PROPOSED CHANGE NO. 1

SOUTHWEST EXPERIMENTAL FAST OXIDE REACTOR

Re: LICENSE DR-15

DOCKET 50-231

Figure 1

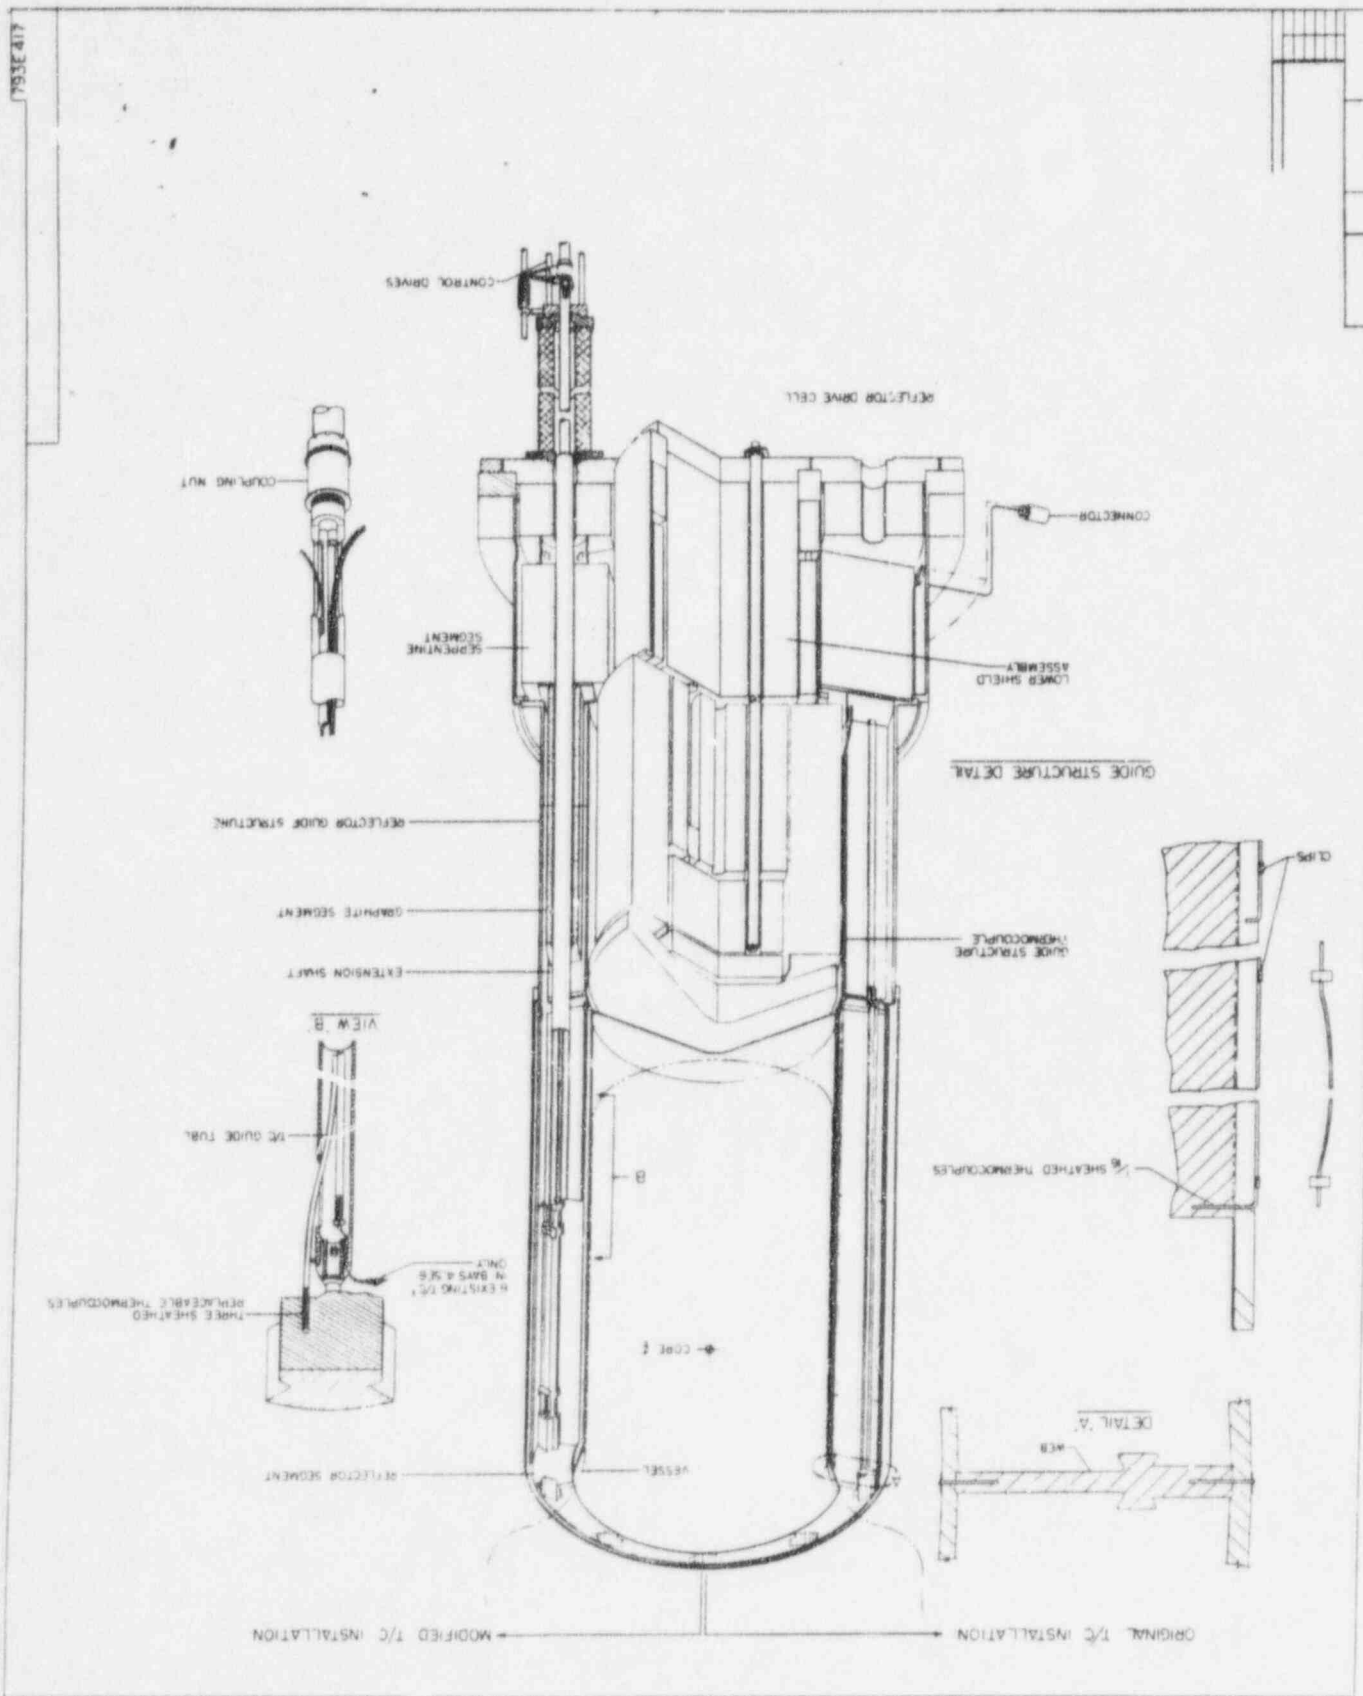
The new thermocouples being proposed for use in the safety system are installed in the lower end of each reflector segment, as shown on the right side of Figure 1. The new thermocouples are commercially available standard instrumentation. They are ungrounded, with magnesium oxide insulation and a 1/16 inch diameter 304 SS sheath. There are no sharp bends in the sheathed portion of the thermocouple, and all of the glass insulated lead wire is accessible for inspection and repair, if required. The thermocouples can be replaced if necessary. However, three thermocouples are installed in each segment to provide two spares for each segment, which will reduce the need for cell entry to replace failed thermocouples.

Modifications made to the replacement shaft consisted of (1) changing the cooling holes at the top of the shaft to a slot (Figure 1, View B) to permit passage of the thermocouple guide tube; (2) adding a similar slot at the bottom of the lower extension shaft; and (3) increasing the inside diameter of the lower section of the extension shaft to 0.896 inch to permit installation of the thermocouple guide tube. A design review of these changes showed that the load carrying capability of the shaft was not affected. The predicted buckling load for the replacement shaft is identical to that of the original shaft. The maximum stress in the upper shaft occurs in a section which was not changed. The maximum stress in the lower shaft was increased 23% due to the increased inside diameter, but these stresses are well below the allowable values.<sup>(3)</sup> Buckling of the thermocouple guide tube will not be a problem since the buckling load is about eight times the maximum applied load.

Flexible leads are provided for the substitute thermocouples to accommodate drive shaft motion during reactor operation and during scram actuation. The design of these flexible leads is identical to that used for the original 18-segment thermocouples which have operated without failure. The leads are wound upward in a spiral fashion around a supporting member to allow for the required flexibility. (See Figure 1.) The leads are then brought outside the reflector drive cell through penetrations.

Figure 2: Temperature Difference Between Thermocouple and Nickel Segment

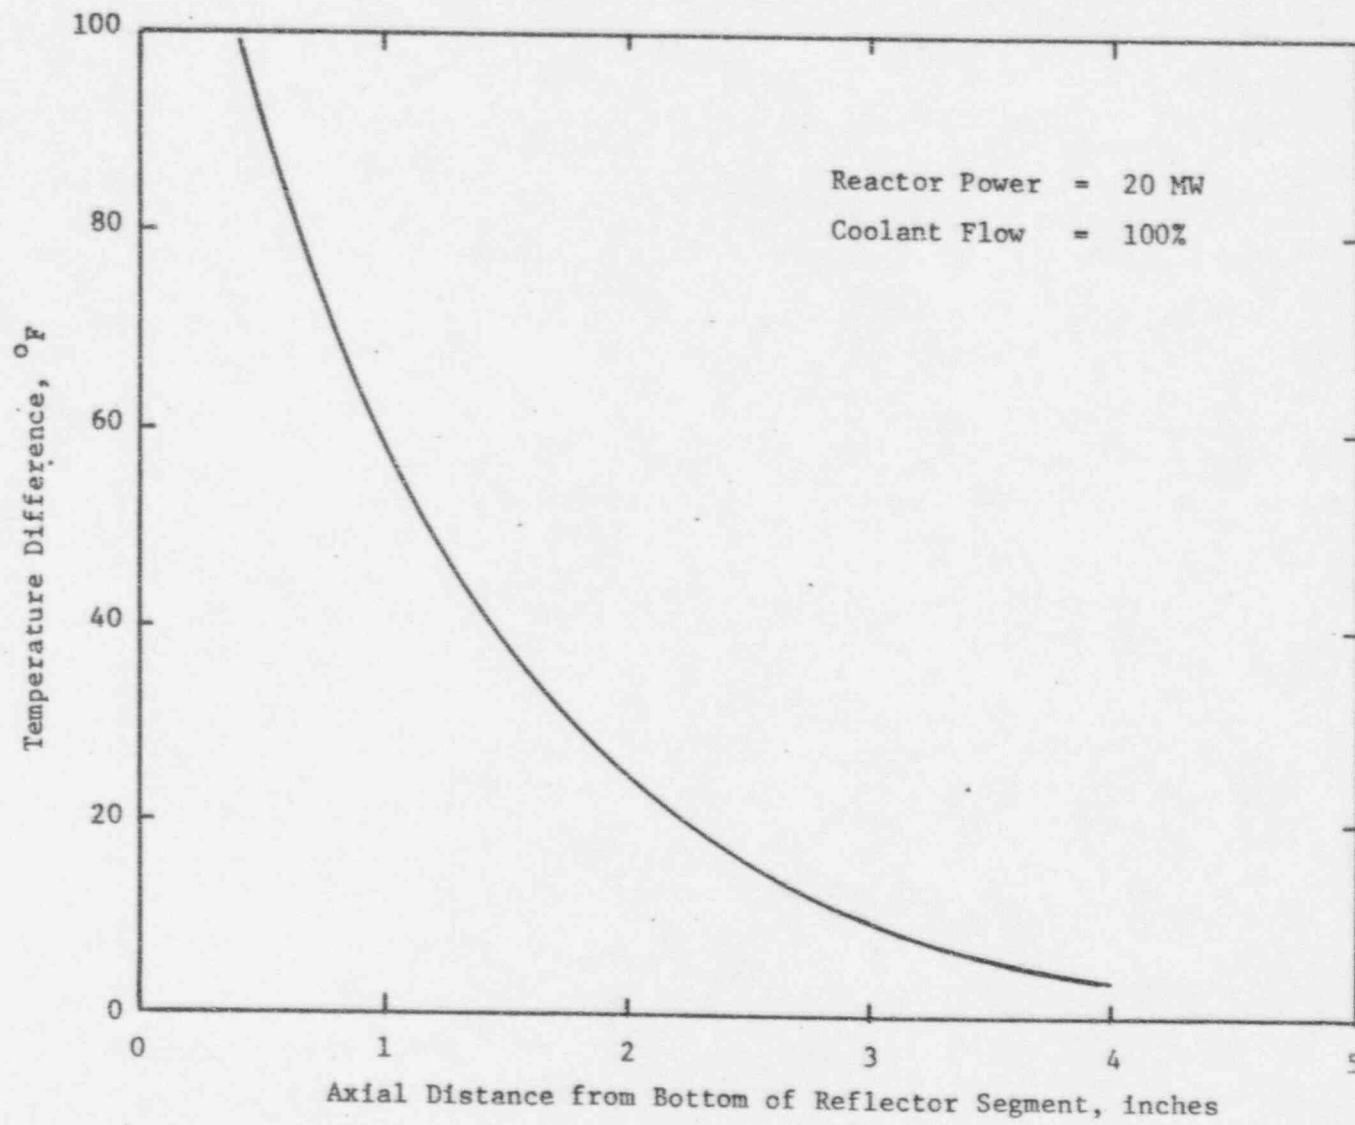
The new thermocouples are installed in the lower end of each reflector segment. (See Section IV, above.) The 3-1/2 inch depth of insertion into the segment was chosen so that the thermocouple temperature would be within 10°F of the nickel temperature at that location, without requiring physical contact between the thermocouple and the nickel. Results from calculations performed using the TGR-V heat transfer code show that a minimum depth of 3 inches satisfies this requirement. (See Figure 2.)

Figure 3: Nickel Segment Temperature at the Thermocouple Location

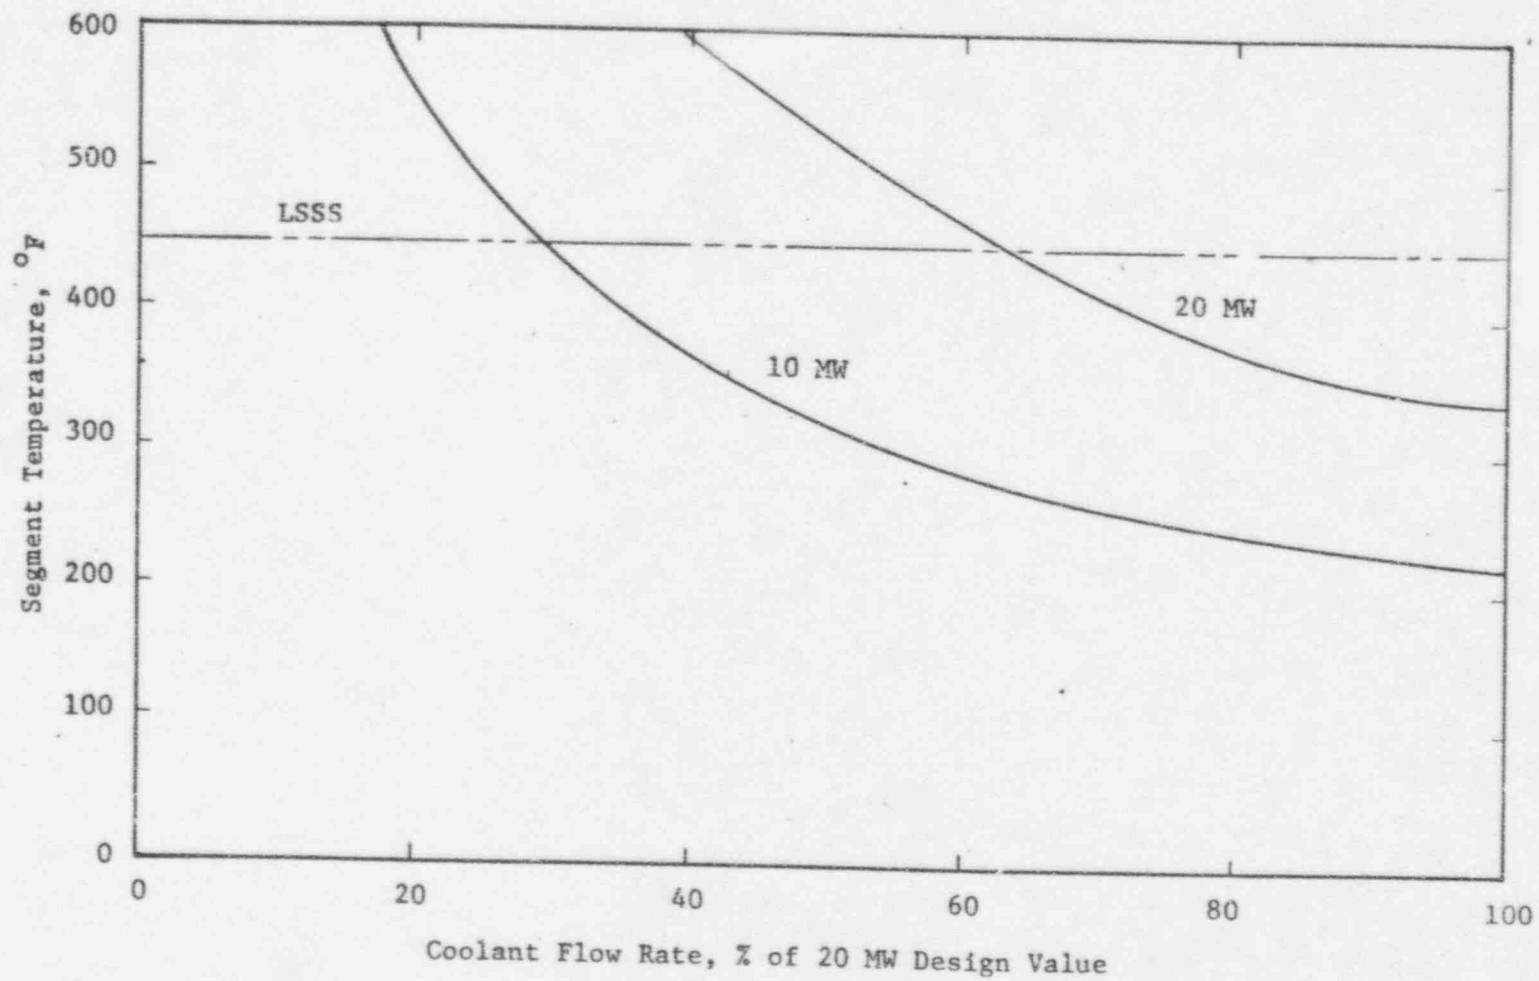
Figure 3 shows the reflector segment temperature at the thermocouple location for two values of reactor power. The proposed Limiting Safety System Setting (LSSS) of 450°F, marked on these curves, would cause a reactor scram if the reflector cooling flow were reduced to 62% of the design flow for 20 MW operation. At 10 MW, the trip would occur at 29% flow, which is 58% of the design flow for 10 MW operation. Thus, at all power levels, the LSSS would cause reactor scram at about 60% of the nominal cooling flow rate for that power level.

Figure 4: Maximum Temperature in the Guide Structure

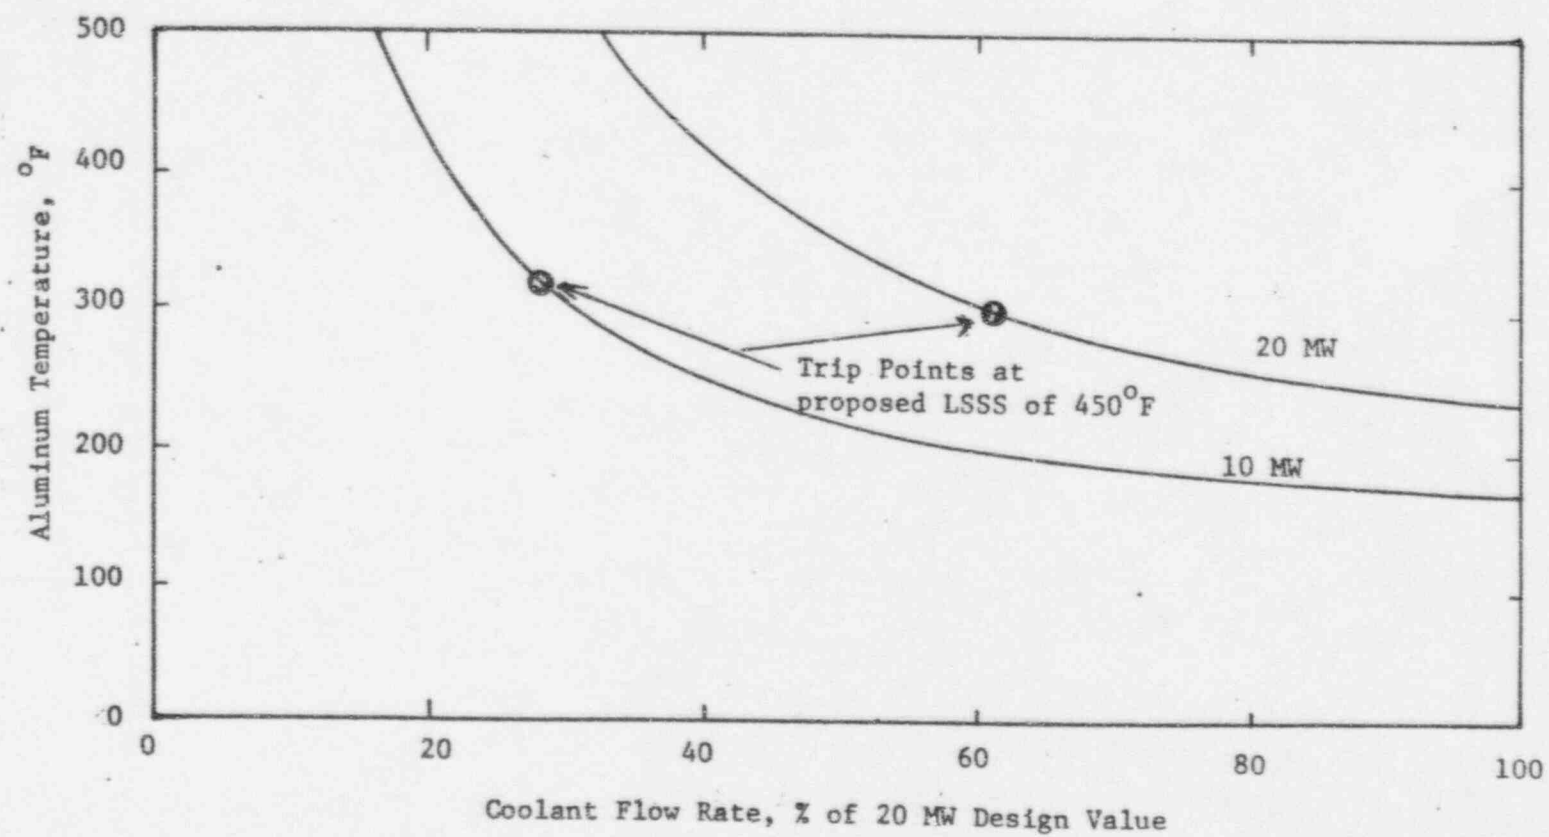
Figure 4 shows similar curves for the maximum temperature in the aluminum guide structure. The proposed LSSS would correspond to a maximum aluminum temperature of 300°F at 20 MW and 315°F at 10 MW, as indicated by these curves.

Figure 5: Component Temperatures at 20 MW

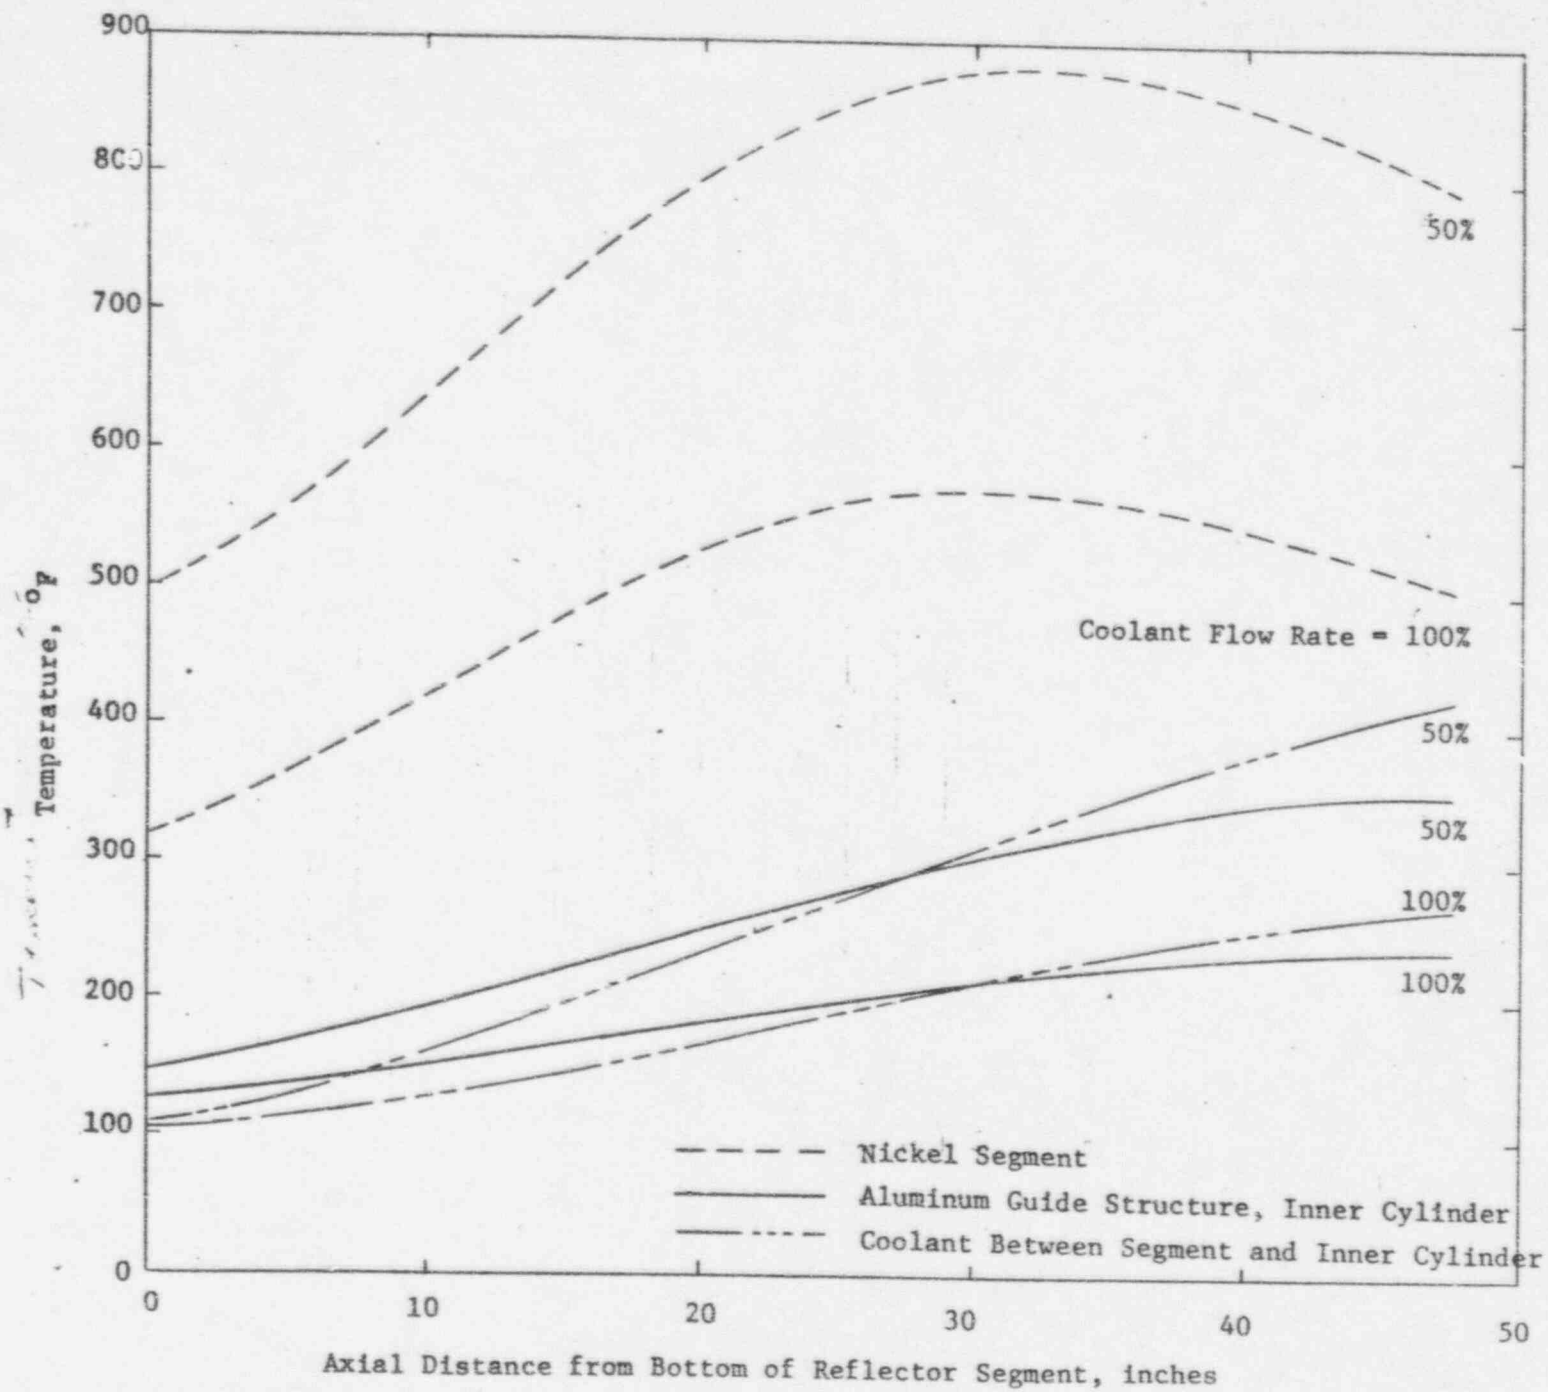
Figure 5 shows the variation of component temperatures with axial position (elevation) for 20 MW operation at 100% and at 50% of the design coolant flow rate.
